Product Bulletin # TDS-218 Rev 2

Alert

Back-up Wrench Gripper Unintended Movement

Figure 1: BUW Gripper Assembly

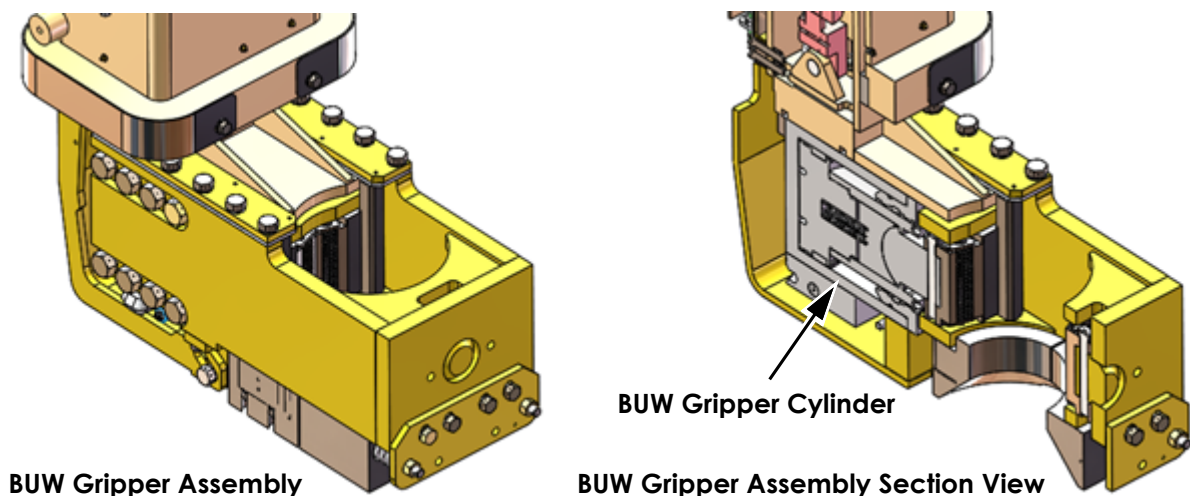
Canrig has been made aware of incidents involving the following unintended movement of the Back-up Wrench (BUW) gripper:

- Unintended closure of the BUW gripper due to back pressure in the hydraulic manifold when using other hydraulic function of top drive that use a large volume of hydraulic fluid such as Pipe handler, torque boost, etc.
- Premature closure of the BUW gripper due to a failed pressure reducing valve.
- Failure to release the gripper due to the low incorrect pressure setting in the pressure reducing valve.

Figure 2: Schematic for the BUW after removing the pressure reducing valve with check valve

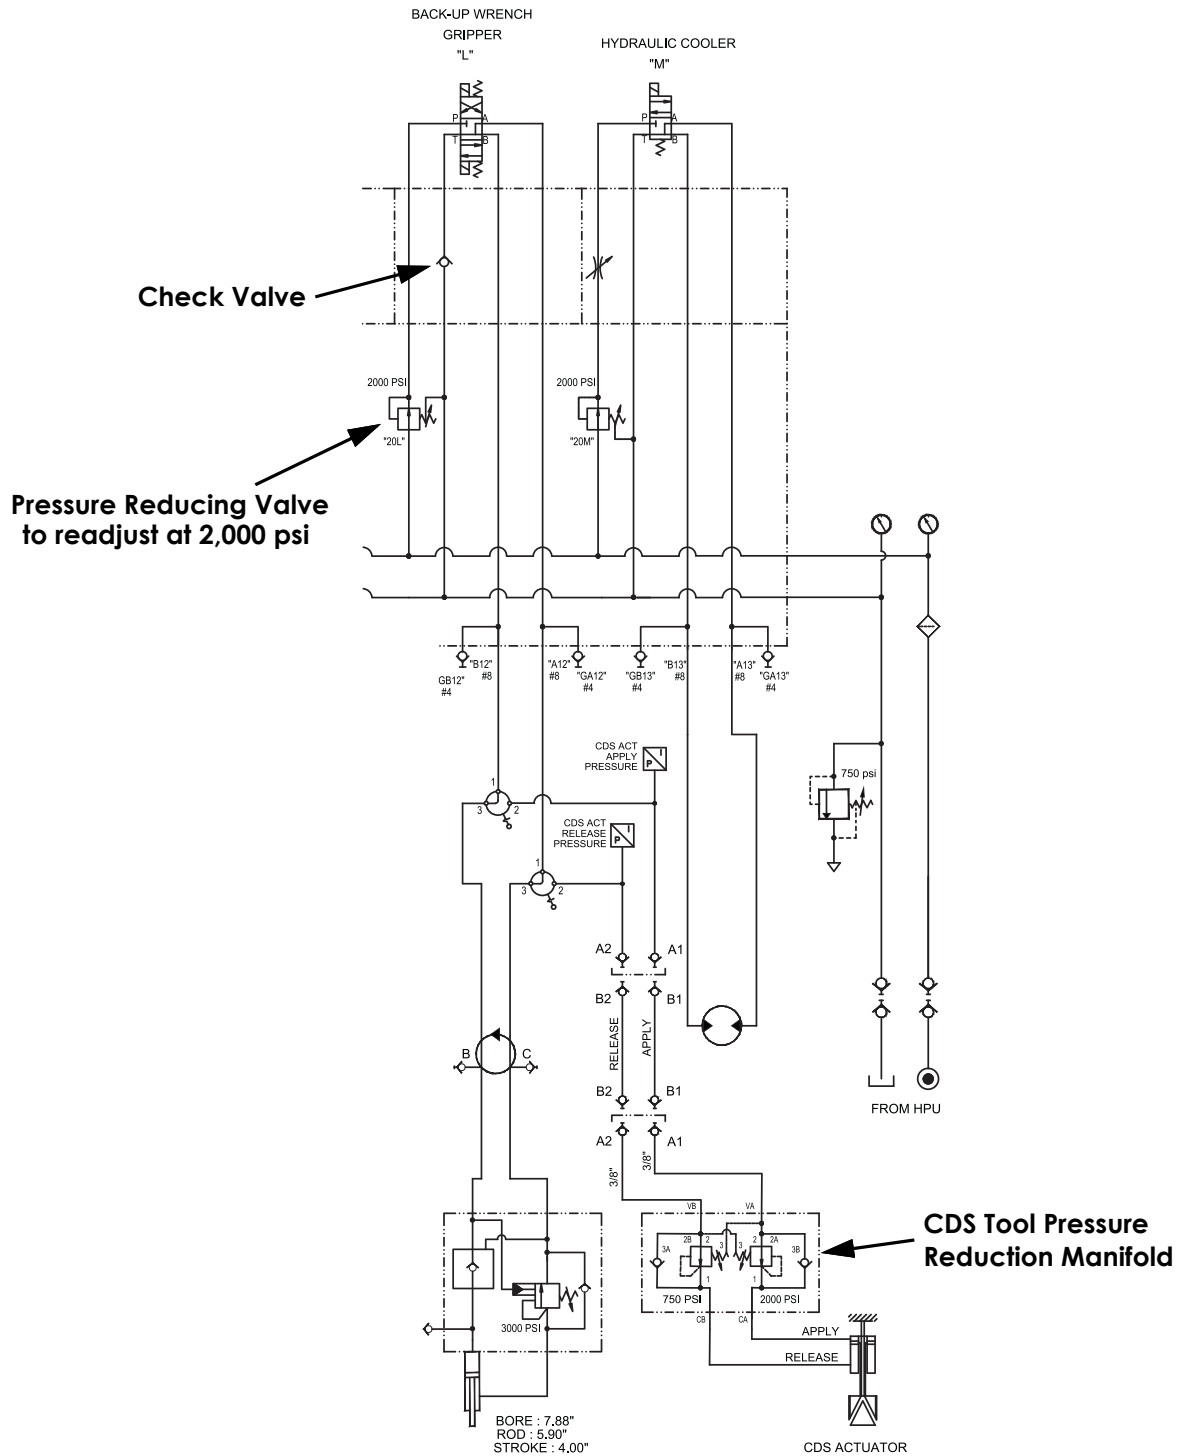
- To prevent this situation, remove the pressure reducing valve on station "L" (BUW gripper) of the top drive hydraulic manifold and install the check valve. Contact RIGLINE 24/7™ to order the kit (Canrig P/N: AY25154) and refer to section below "Check Valve Installation" on page 5. See Figure 2 on page 3 for schematic included with check valve stack attached to top drive hydraulic manifold.

- After removing the 750 psi pressure reducing sandwich valve, ensure the pressure reducing valve cartridge located at the 20L port on the hydraulic manifold is set to 2,000 psi.

Figure 3: Schematic for the BUW after removing the pressure reducing valve without check valve

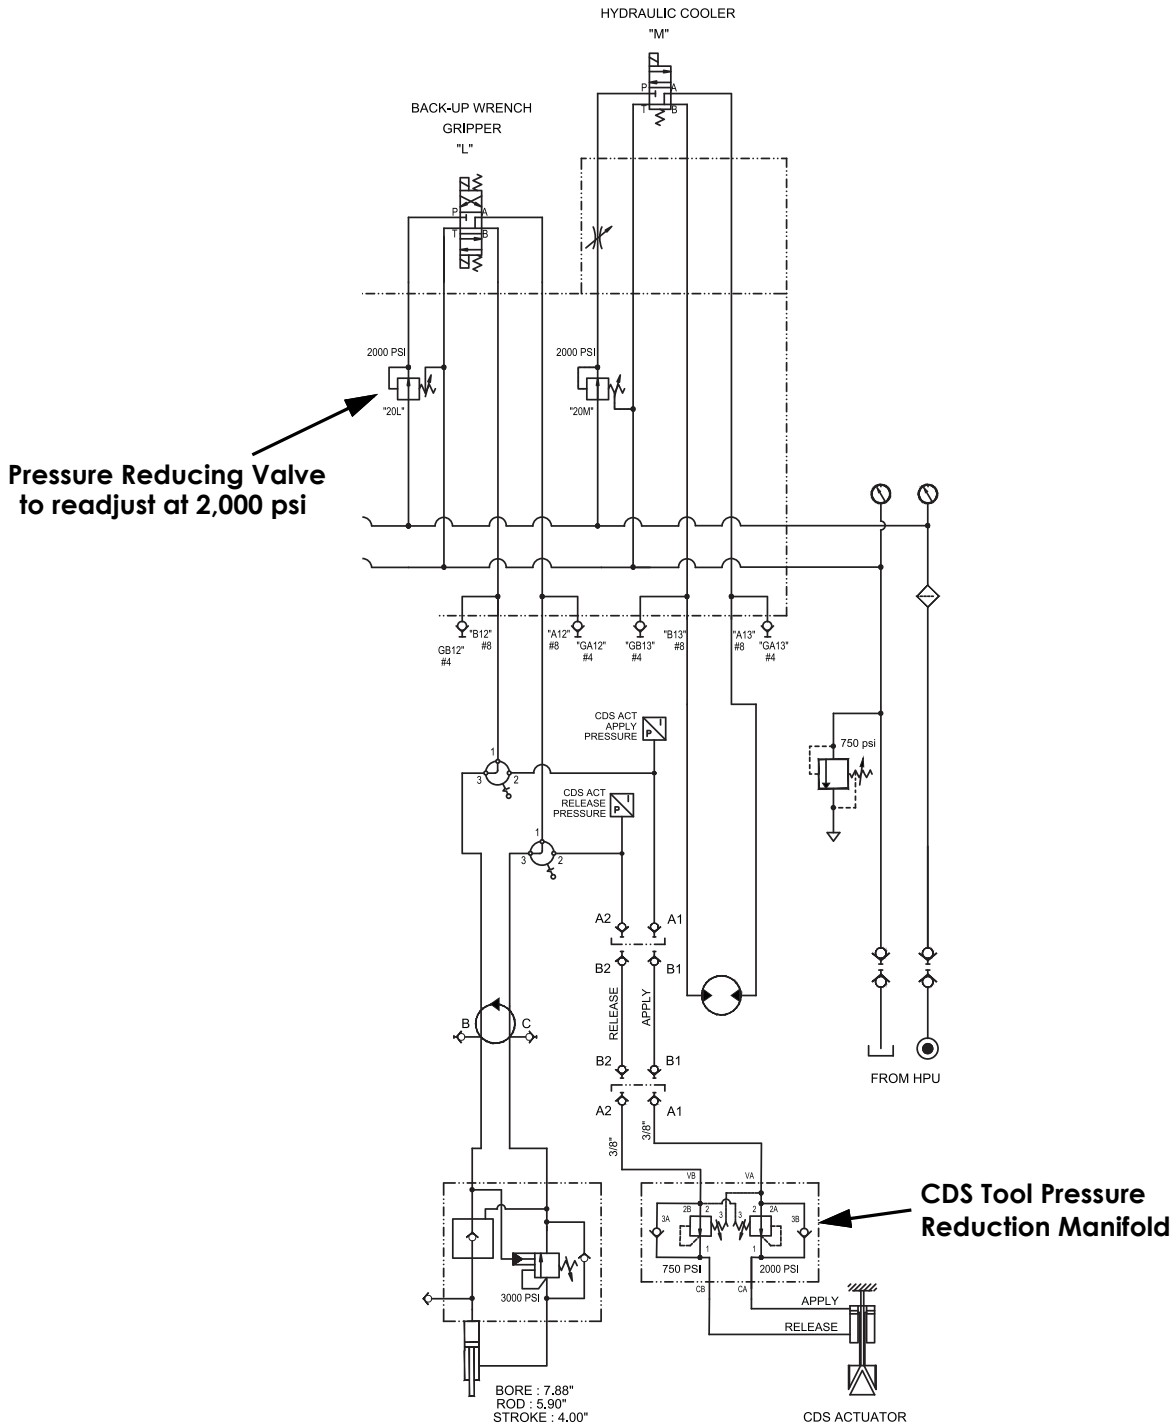
- If the kit (Canrig P/N: AY25154) is not being implemented per above, Canrig strongly recommends to remove the pressure reducing sandwich valve and install the BUW solenoid valve (DCV) back on manifold using socket head fasteners (Canrig P/N: SH-10-24-0200). See Figure 3 on page 4 for schematic.

Figure 4: Hydraulic manifold

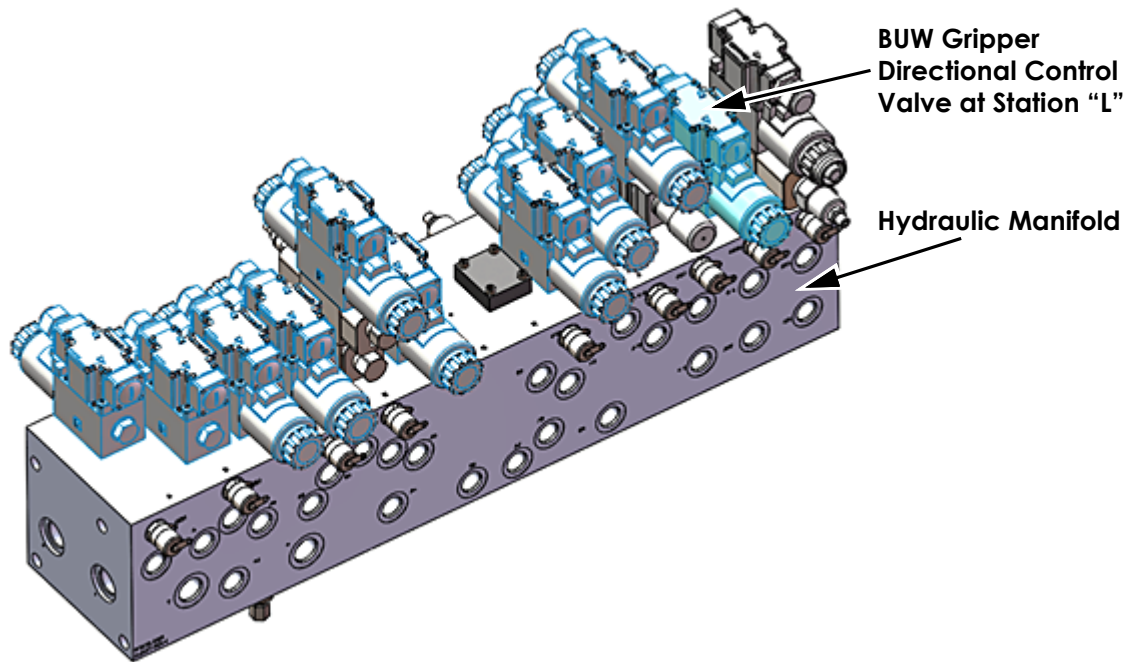
1. See Figure 4 to locate the BUW gripper valve bank (station L) on the top drive hydraulic manifold.

Figure 5: Pressure reducing valve

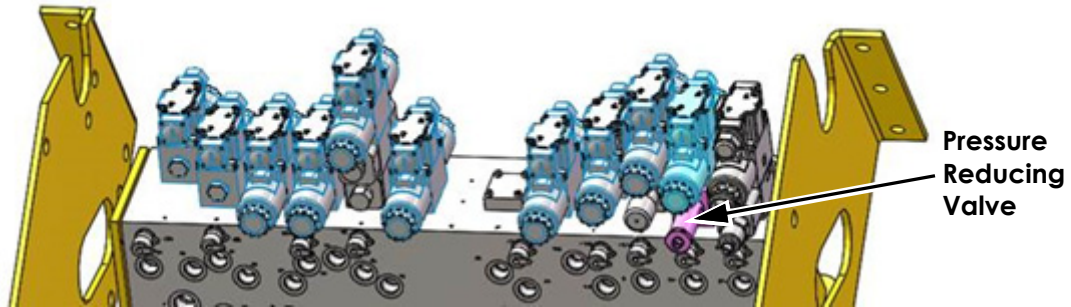
2. Unscrew the fasteners to remove the pressure reducing valve (PRV) as shown in Figure 5. If the check valve is not available then install the BUW valve bank using the socket head fasteners (Carrig P/N: SH-10-24-0200).

Figure 6: Installing check valve

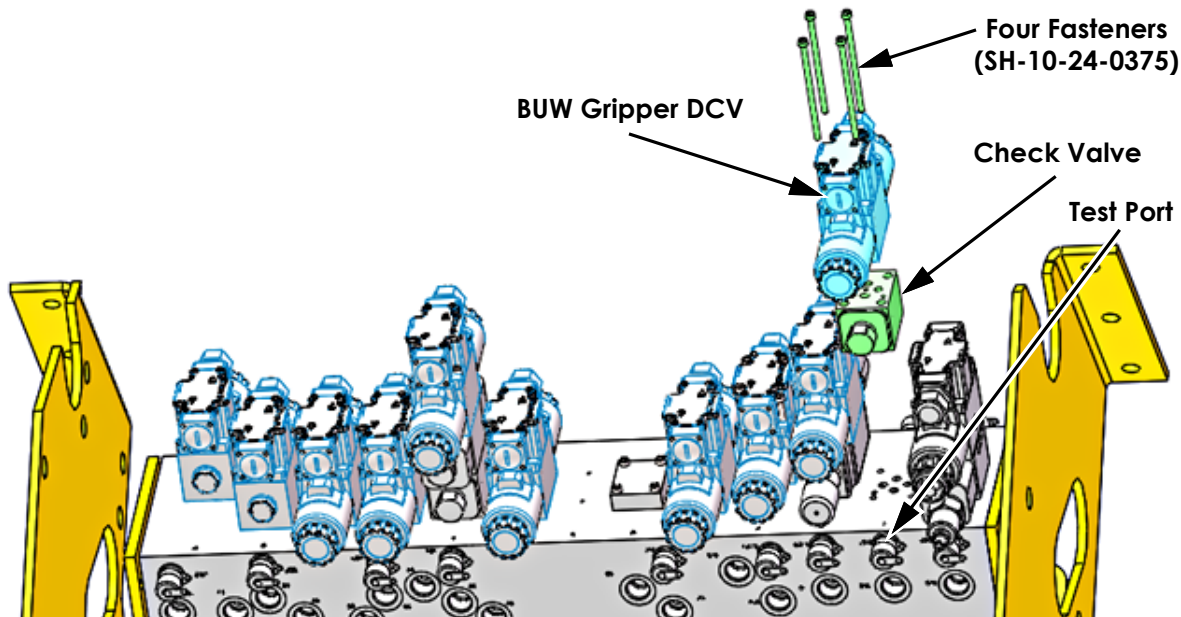
3. Using the fasteners from the kit, install the check valve assembly (P/N: H07-1010-030) between the BUW gripper DCV and the hydraulic manifold as shown in Figure 6. Torque the fasteners to 6.5 ft-lbs using Loctite[®] 242.

Check valve knob must be oriented toward the hydraulic manifold test port as shown in Figure 6.
